**Delaware River Joint Toll Bridge Commission
Request for Proposals
Contract No. DB-768A
Capital Project: 2122A
Network Video Management System (NVMS)
Integrator Services
Addendum No. 3**

ADDENDUM NO. 3

CONTRACT NO. DB-768A

EXHIBIT B: DRJTBC ESS OVERALL SYSTEM RISER

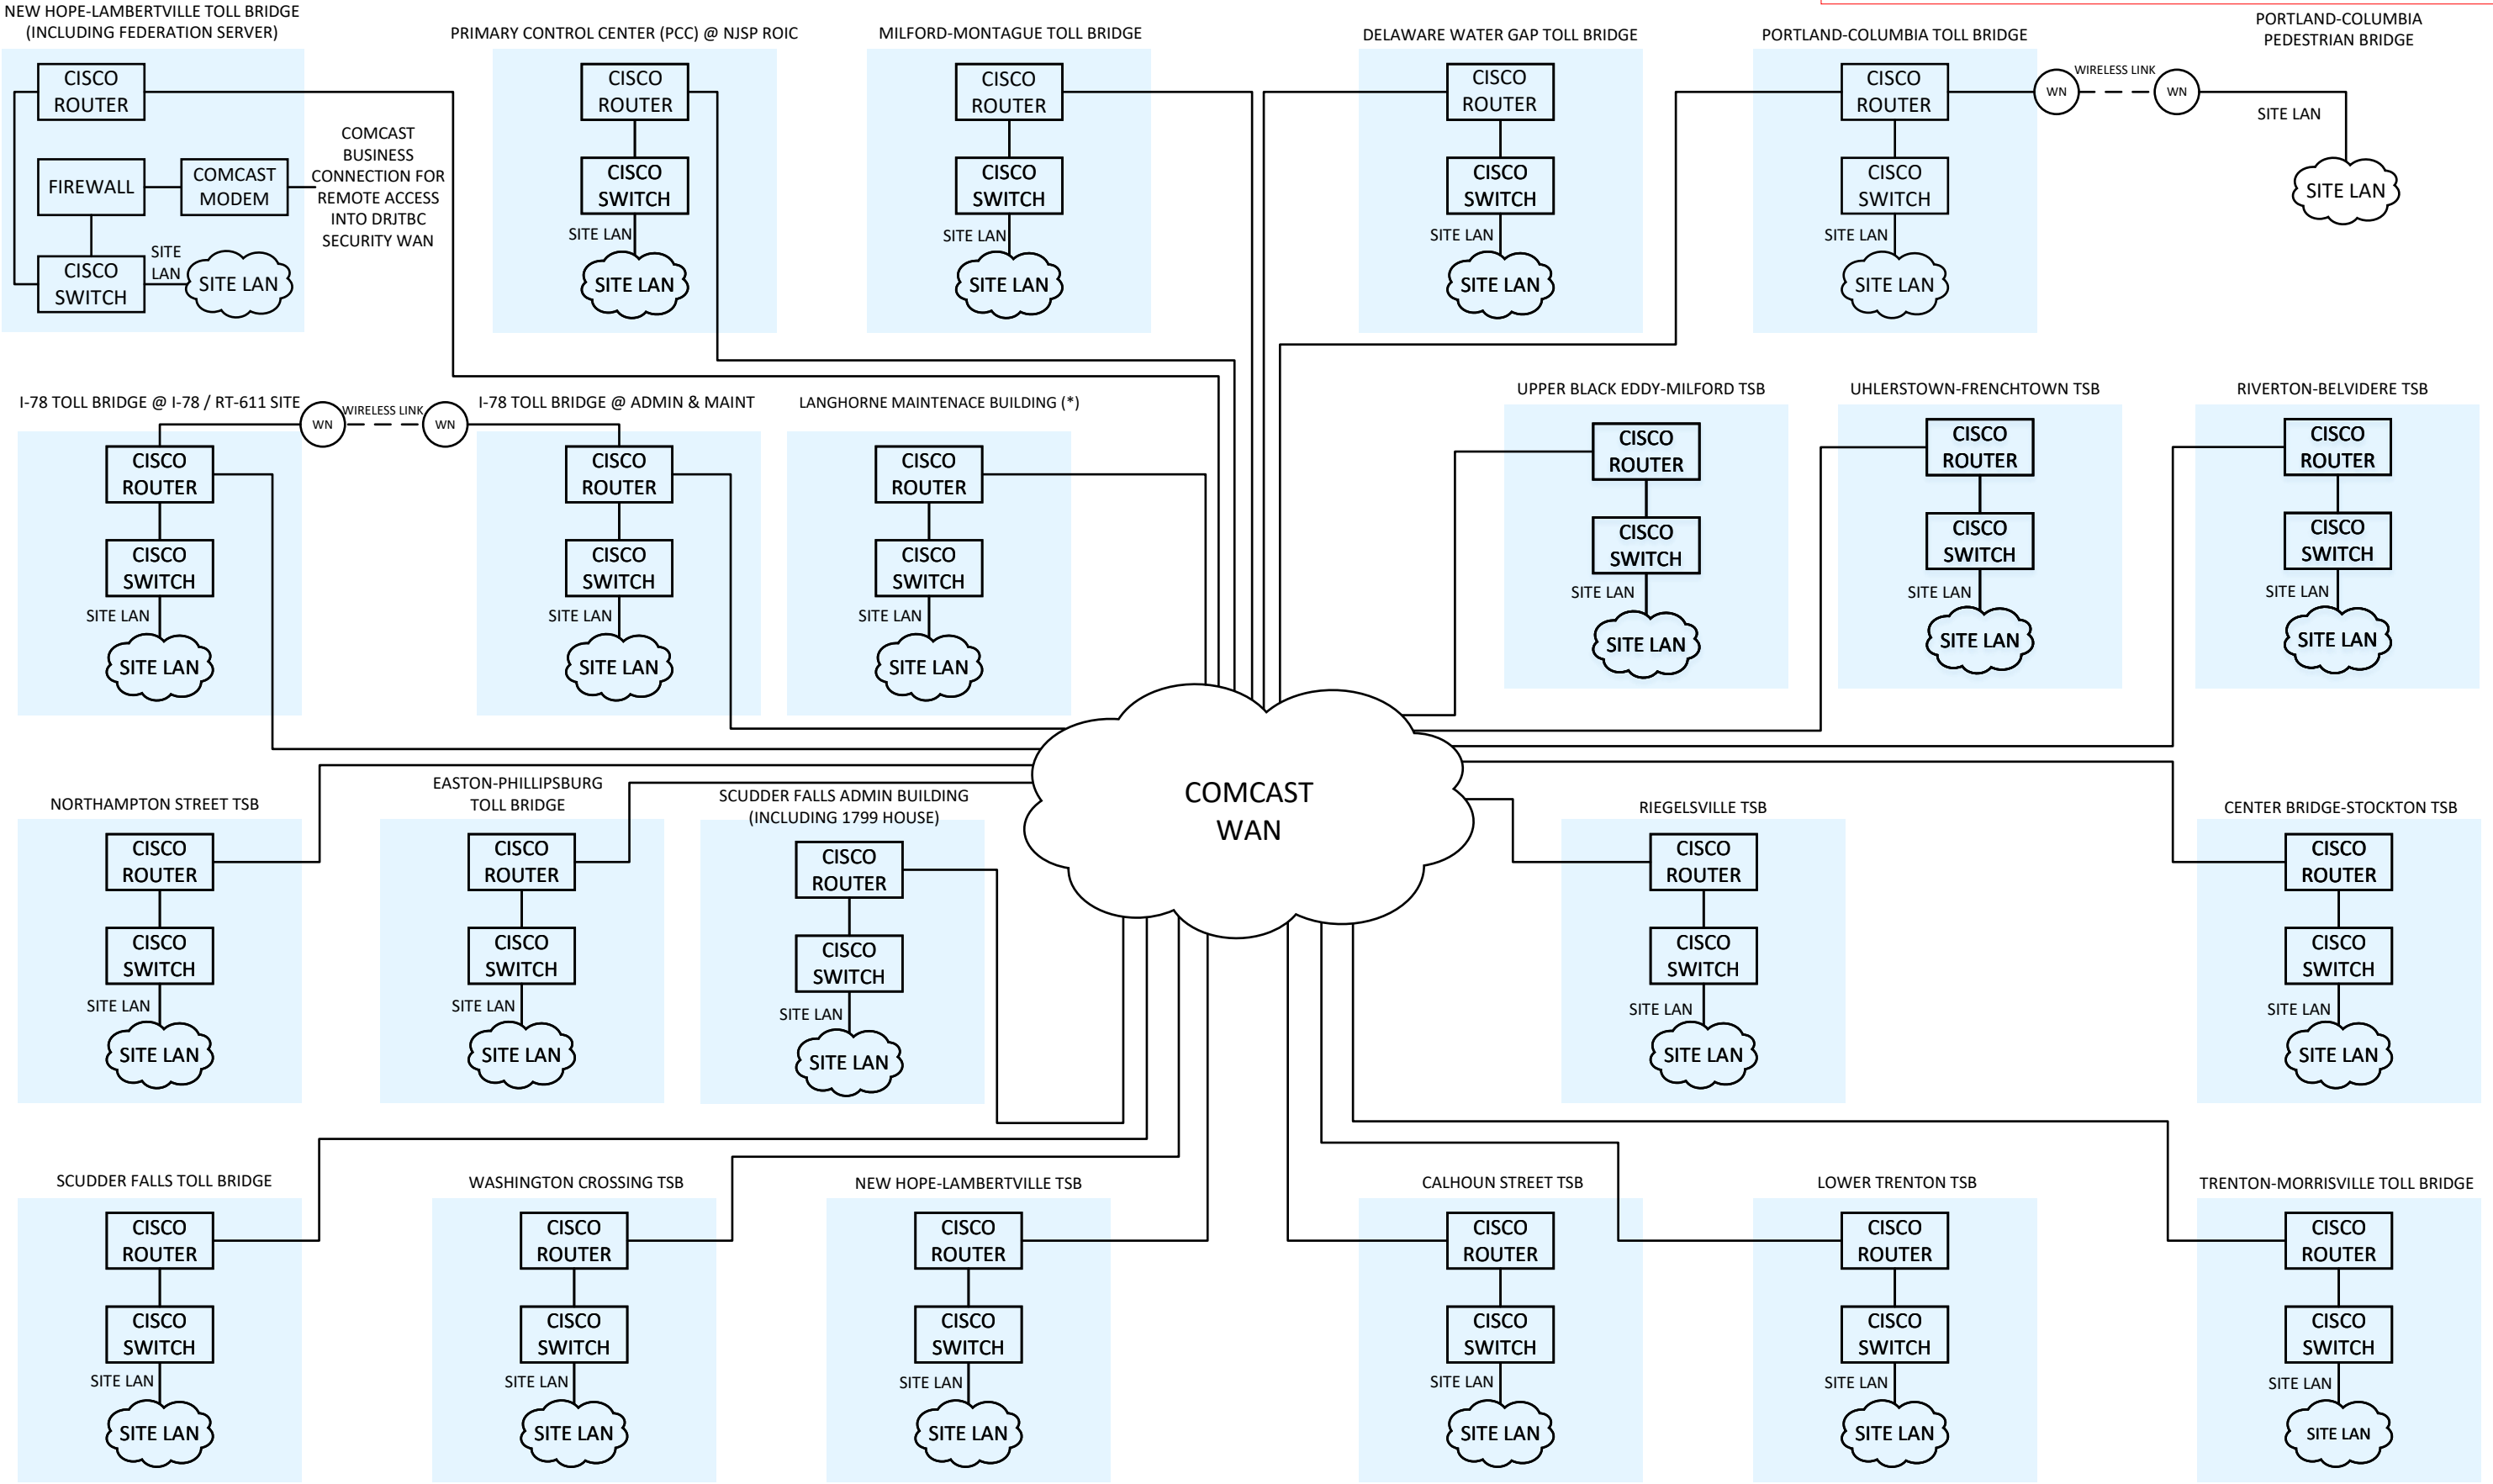
Response: The ESS currently consists of twenty-one (21) wide area network (WAN) sites with a 22nd site, Langhorne Maintenance Building, identified as a new site to be added as part of a Future Project (Refer to Tab 11, Exhibit B DRJTBC ESS Overall System Riser and modifications to the same contained herein this Addendum No. 3). The Hardware/Software Inventory lists have been modified to correspond to the wide area network (WAN) sites and expanded to include lists for each of the four (4) Future Projects (Refer to Tab 11, Exhibit A Hardware/Software Inventory and modifications to the same contained herein this Addendum No. 3).

Response: The ESS currently consists of twenty-one (21) wide area network (WAN) sites with a 22nd site, Langhorne Maintenance Building, identified as a new site to be added as part of a Future Project (Refer to Tab 11, Exhibit B DRJTBC ESS Overall System Riser and modifications to the same contained herein this Addendum No. 3). Each site includes its own
